Barry Molloy & David Gee

Ref: Observation to Barrington Tower Strategic Housing Development (SHD) at Brennanstown Road, Dublin 18 (An Bord Pleanála [ABP] Ref. TA06D.313281).

Fig 4. Site section from Brennanstown Road showing rising elevation on the road from the cottage on the east, to the development on the west (adding to overlooking/shadowing aspect).

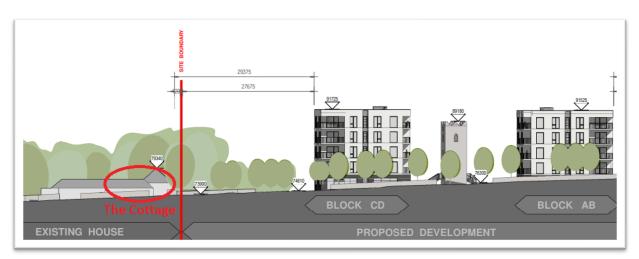
Privacy, overlooking and shadowing is of great concern to us and the idea of facing five and ten storey buildings with a multiplicity of glass balconies addressing what we currently regarded as our private living spaces is extremely worrying. The applicant proposed to address this with their boundary treatment plan, which would require enough trees to have the same effect of placing our home within a cave. The proposed development will devalue properties like ours in the immediate vicinity. Far from preserving the amenity of existing residences, this proposed vista destroys any peace of mind relating to potential future development. It's not about objecting to other families living opposite us, as an appropriately scaled proposal would enhance the area, but is about being overlooked from a height of eight storeys mere metres away, and having hundreds
